## BellBendCOLPEm Resource

**From:** Temple, Jeffrey  
**Sent:** Thursday, October 08, 2009 9:17 AM  
**To:** Jones, Joe A  
**Cc:** BellBendCOL Resource  
**Subject:** FW: BBNPP RAI 47 File Continuation  
**Attachments:** PSP Response Enclosure pgs 41-59.pdf; PSP Response Enclosure pgs 28-40.pdf

**RAI No.:** 47

**ETE-9: Traffic Capacity, Roadway Segment Characteristics**

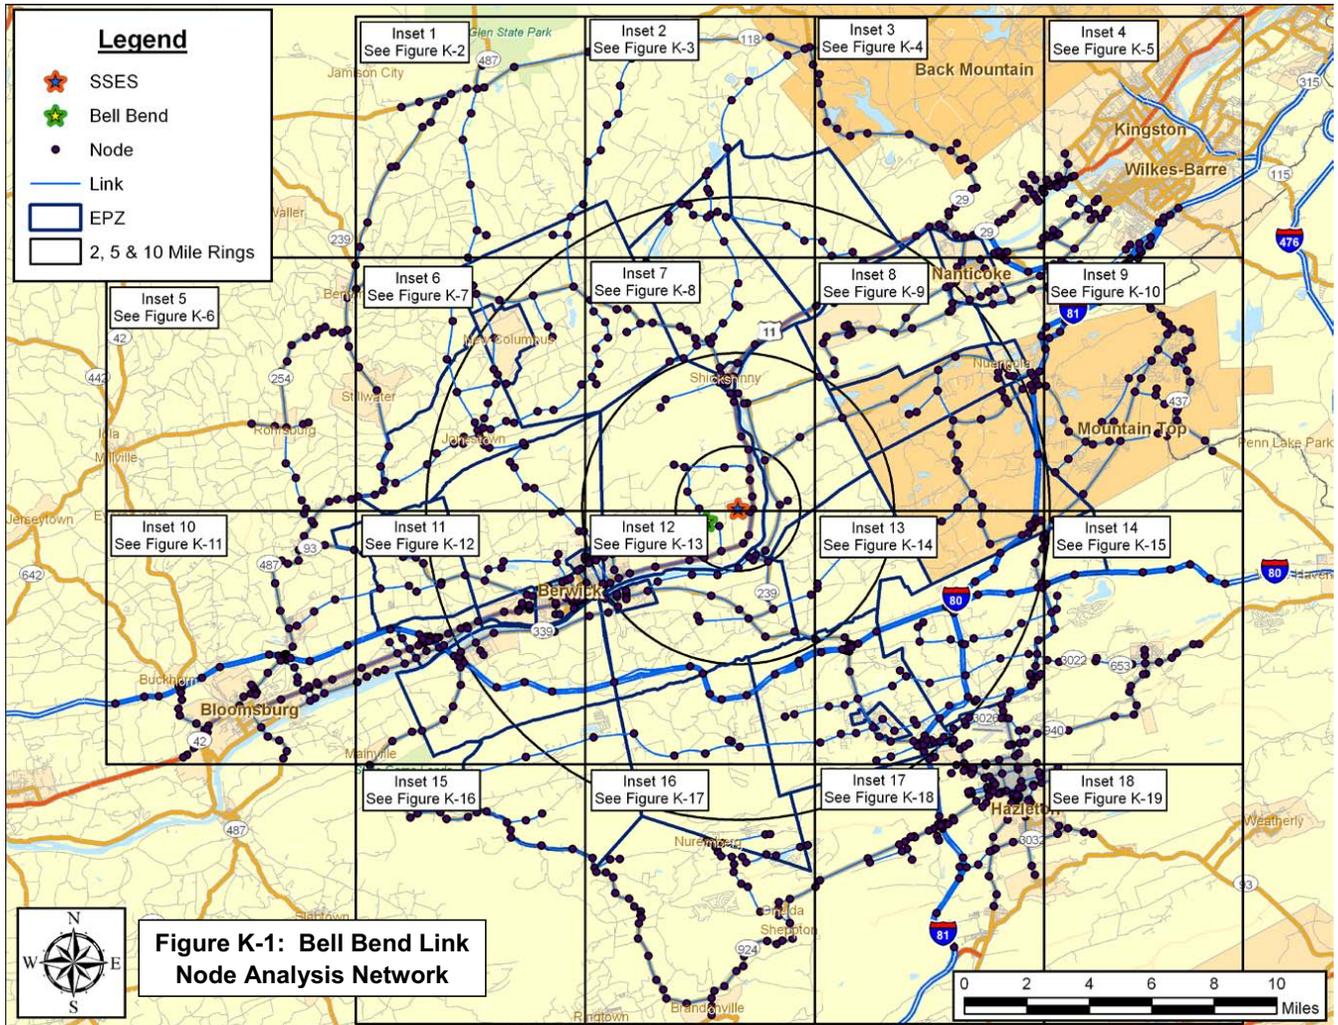
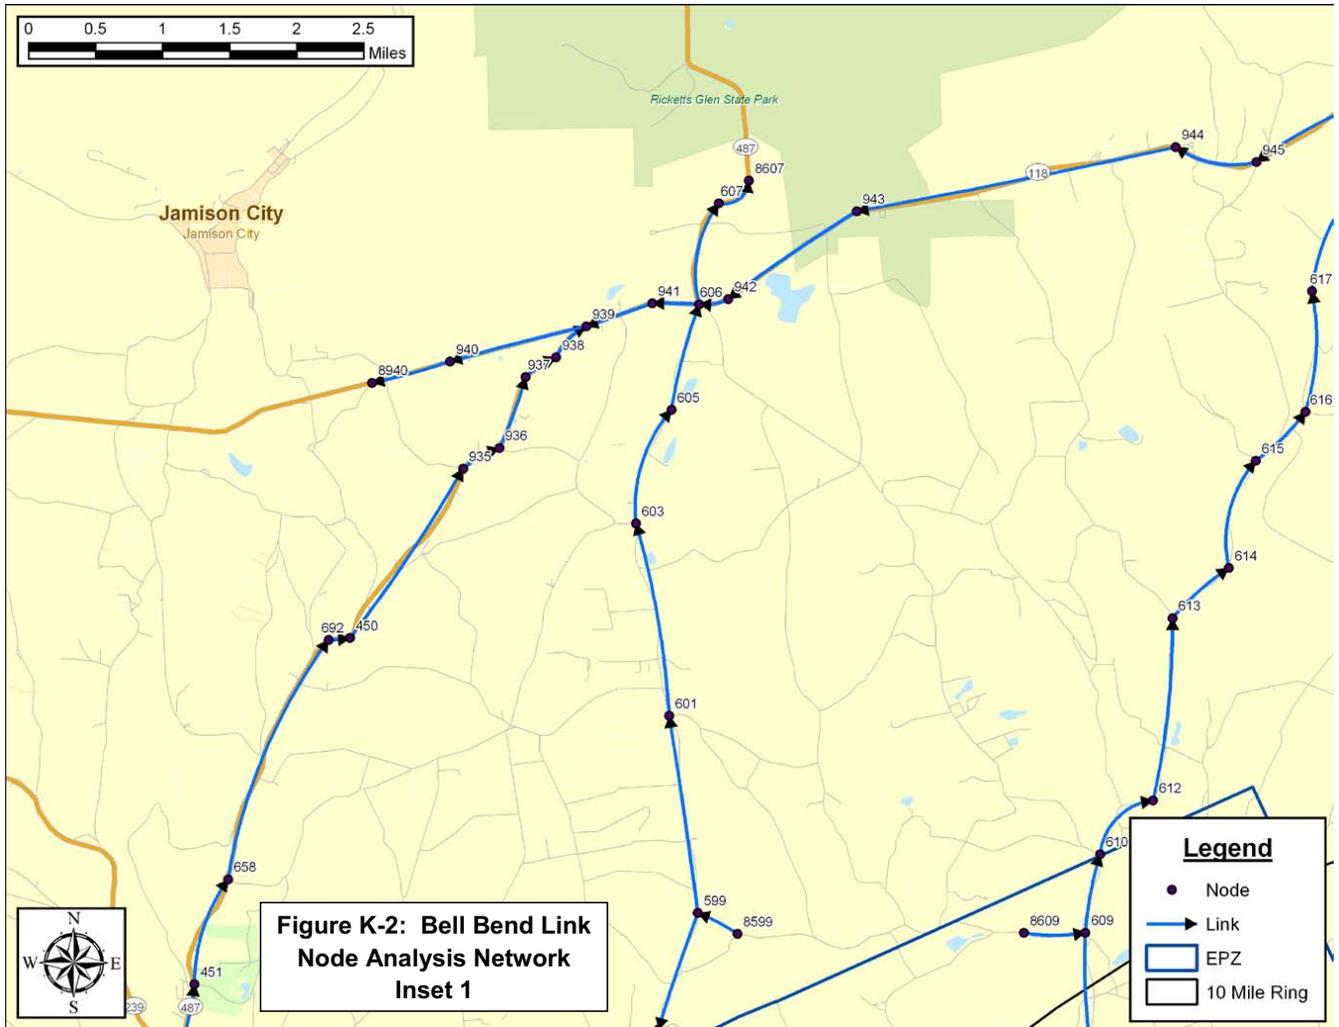
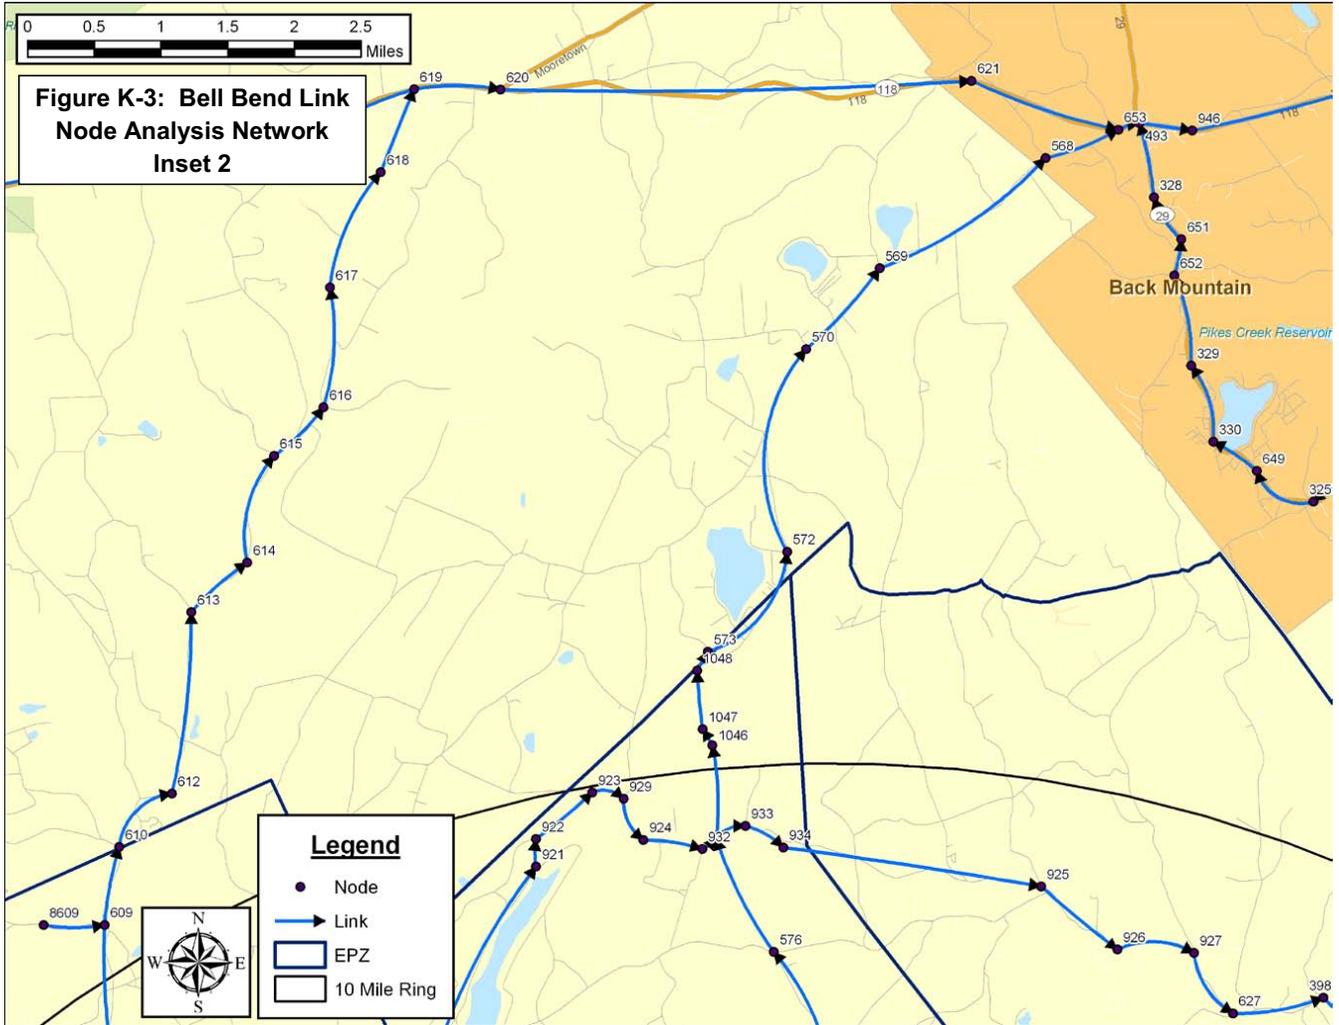
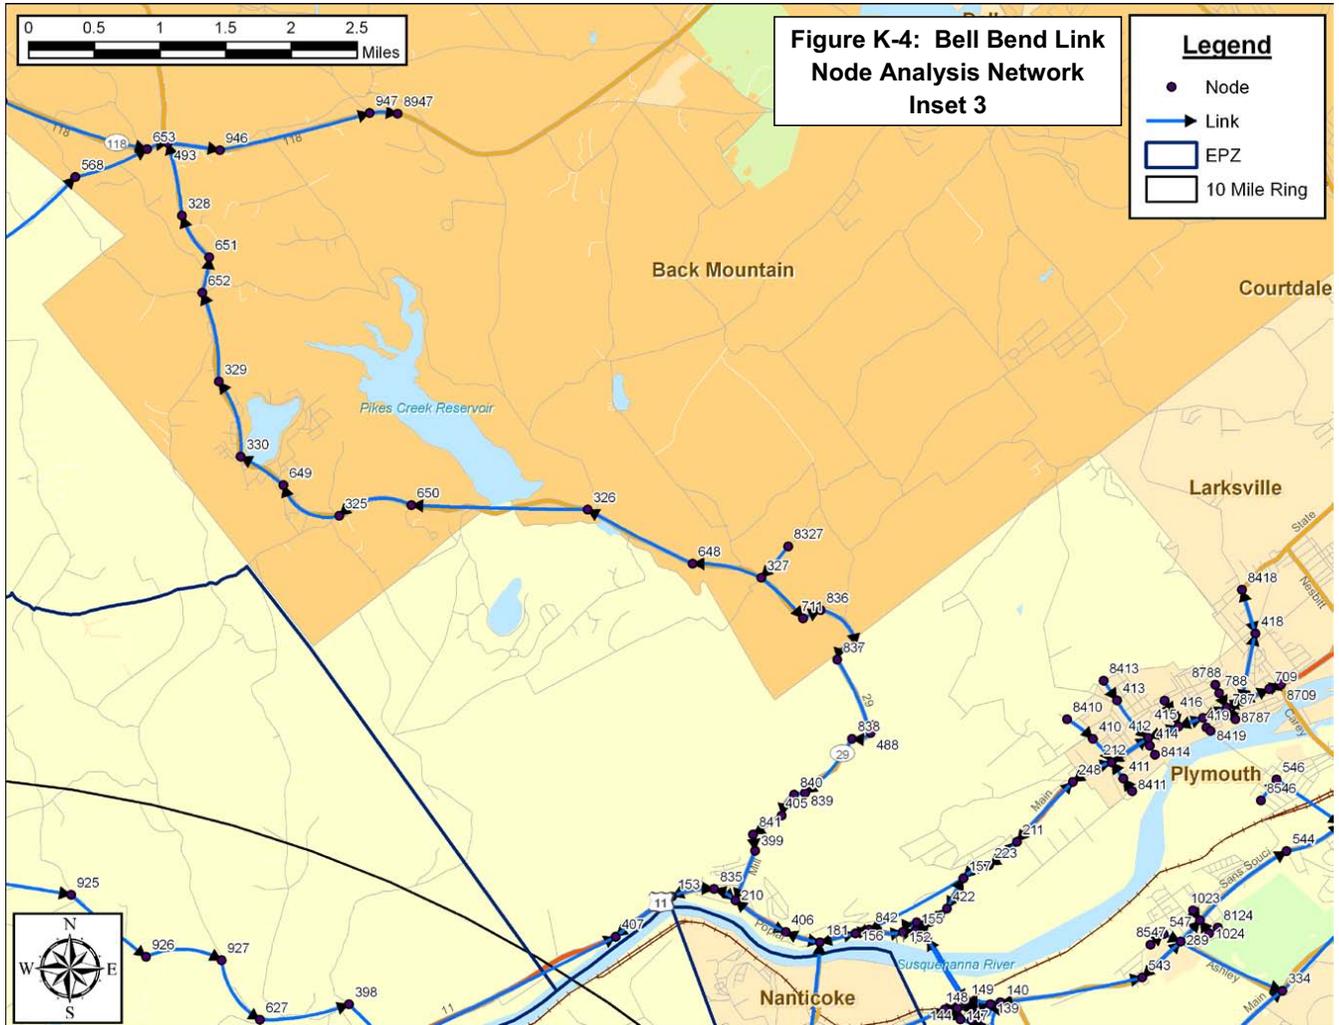
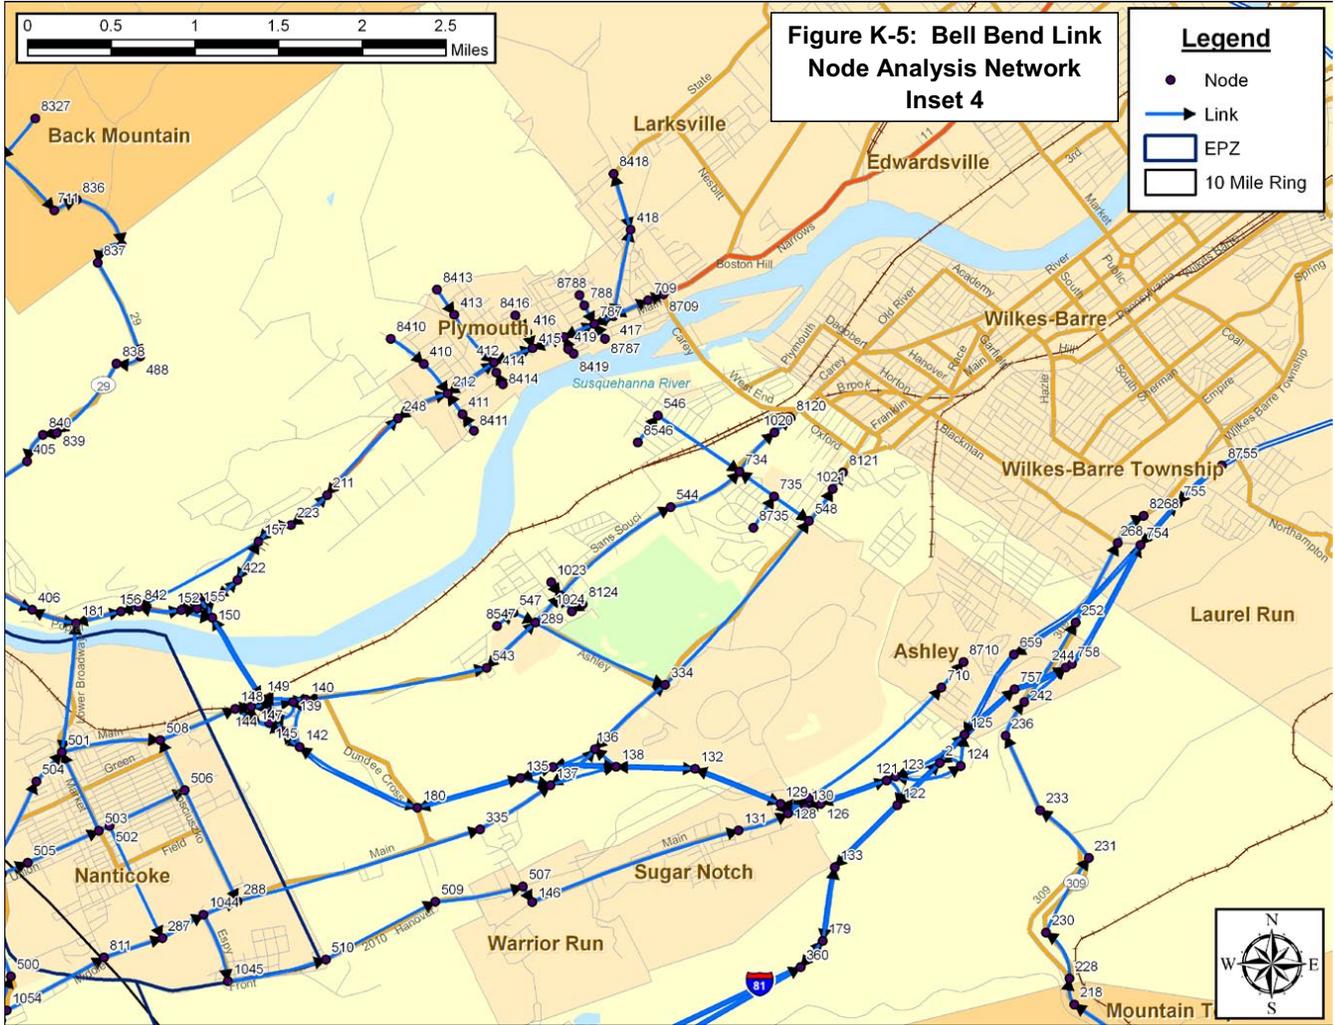
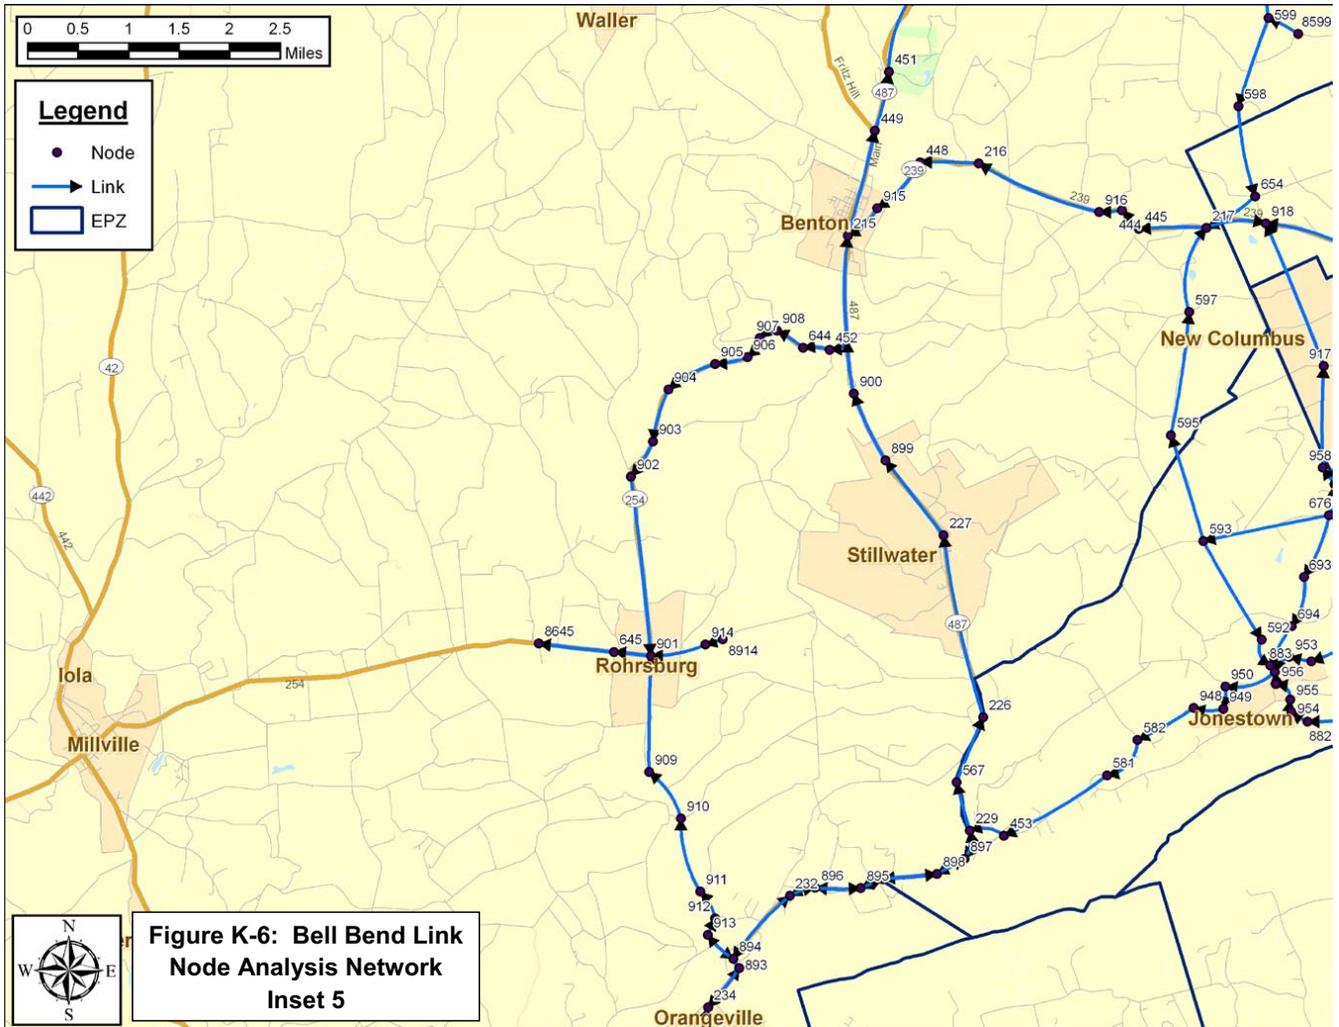
- A. Figure 1-2, "SSES/Bell Bend Link-Node Analysis Network," shows the nodes used in the analysis, but the nodes are not labeled to correspond to Appendix K, "Evacuation Roadway Network Characteristics." Provide a map in a revision to the ETE report that includes legible node numbers that correspond to Appendix K.

Due to the scale of Figure 1-2, the node labels and link directional arrows were removed for clarity. Figure 1-2 will be divided into several figures in Appendix K in a future revision of the ETE report, which will show the directional arrows and annotate the nodes within the link-node analysis network. The reference to Figure 1-2 in Section 1.3 will be revised to reference the newly added figures in Appendix K; these newly added figures are attached to this response.

As discussed in Section 1.3, a computerized link-node analysis network was constructed to model the evacuation roadway network within the study area. Figure K-1 provides an overview of the link-node analysis network. The figure has been divided up into 18 more detailed figures (Figures K-2 through K-19) which show each of the links and nodes in the network.

4. Insert new figures K-1 through K-19 into Appendix K in a future revision of the ETE Report.
5. Modify the last paragraph in the subsection, "Field Surveys of the Highway Network" to read in a future revision of the ETE Report:

Figure 1-2 presents the link-node analysis network that was constructed to model the evacuation roadway network in the EPZ and Shadow Region. The directional arrows on the links and the node numbers have been removed from Figure 1-2 for clarity. The detailed figures K-2 through K-19, provided in Appendix K depict the analysis network with directional arrows shown and node numbers provided. The observations made during the field survey were used to calibrate the analysis network.
